FINAL DRAFT
EN 15273-2:2013

FprA1

March 2016

Railway applications - Gauges - Part 2: Rolling stock gauge

16 Change to Subclause P.2.1.5.1, Static reference profile for the lateral parts and upper parts

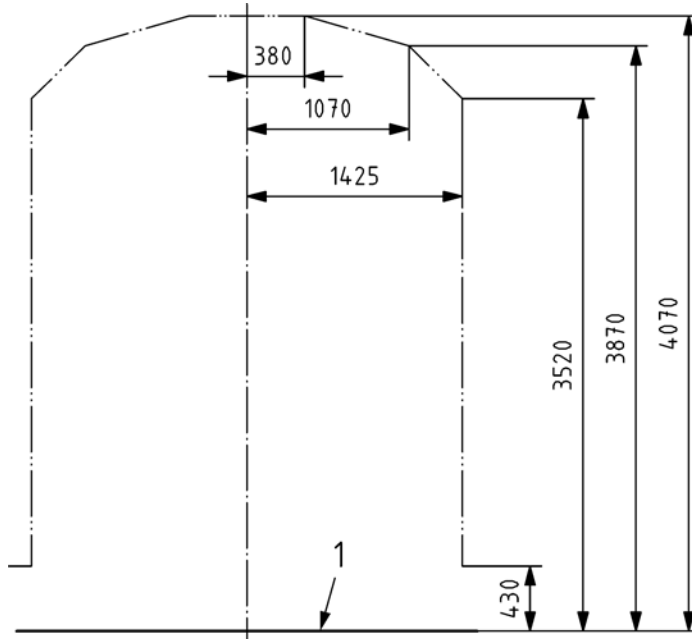
Replace the existing Figure P.6 with the following:

17 Change to Subclause P.2.1.5.2, Static reference profile for the lower parts

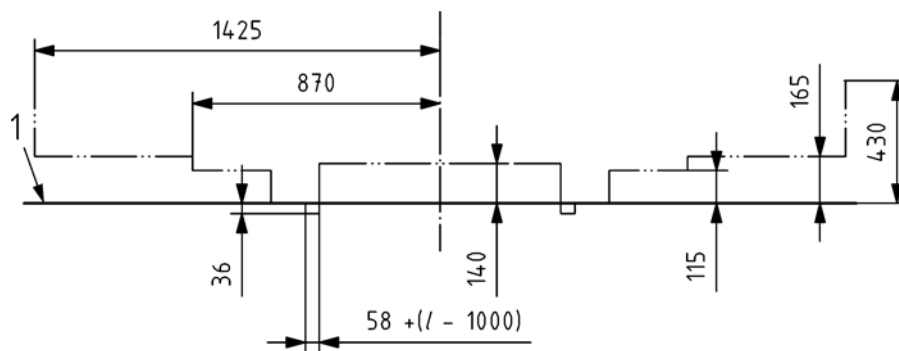
Replace the existing Figure P.7 with the following:
